CERTIFICATE OF APPROPRIATENESS

Property: 614 W. Main Street, Tract 6 & 7, Block 8, Lockhart Connor & Barziza Subdivision. The property includes a historic 1,887 square foot one-story wood frame single family residence situated on a 5,000 square foot interior lot.

Proposal: Alteration – Install replacement skirting along the perimeter of the existing structure on the north, west, and east elevations. The applicant has proposed three options. Option A will be comprised of smooth cementitious panels with 1” x 4” trim. Some panels will feature metal vents with 1” x 2” trim. The panels will be approximately 40” tall (from grade to the floor) and range from 6’-7’ in width. Options B and C are metal panels of different designs.

Recommendation: Denial - does not satisfy criteria 1, 4, 5, 6, 7

PROPOSED SKIRTING DETAIL

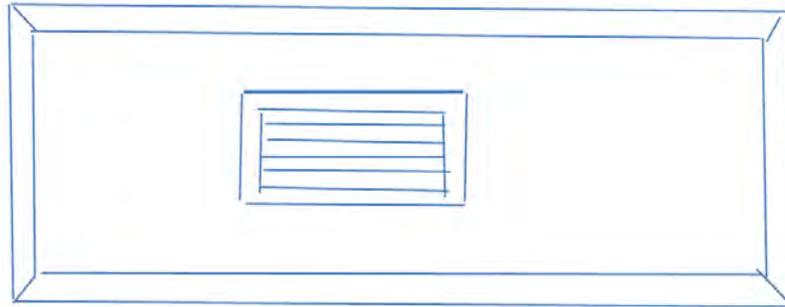
<i>The proposed design of the replacement skirting with simple panels does not preserve the historical character of the property. Due to this structure's proportions, it is likely that this structure would have had a more substantial skirt. A lap siding skirt would be a more typical condition found within the district for this style of house.</i> |

<i>Due to the existing historic structure having such a tall foundation and finished floor height, which would have been concealed (in part to protect the framing), the skirting would have historically been a prominent and distinguishing feature of this building. Flat panels installed around the perimeter of the structure, spanning such a height, are not typical within the district. A more typical skirting condition would be a more substantial skirt featuring lap siding.</i> |

<i>The flat simple panels do not replicate the distinctive stylistic exterior features or examples of skilled craftsmanship that characterize this building. A more integrated and elaborate skirting systems would be more historically appropriate for this structure.</i> |

<i>The proposed flat panels are not typical or compatible with what would have been used on this structure. Skirting featuring lap siding, whether flared or not, would be more appropriate.</i> |

<i>Many of the exterior elements of this structure have since been removed, including the original siding and skirting. However, skirting design on similar houses, found within this and other districts, indicate that due to the tall foundation and finished floor height, as well as the visual prominence of the foundation, it is likely that the skirting on this structure was more substantial than simple panels, as proposed.</i> |
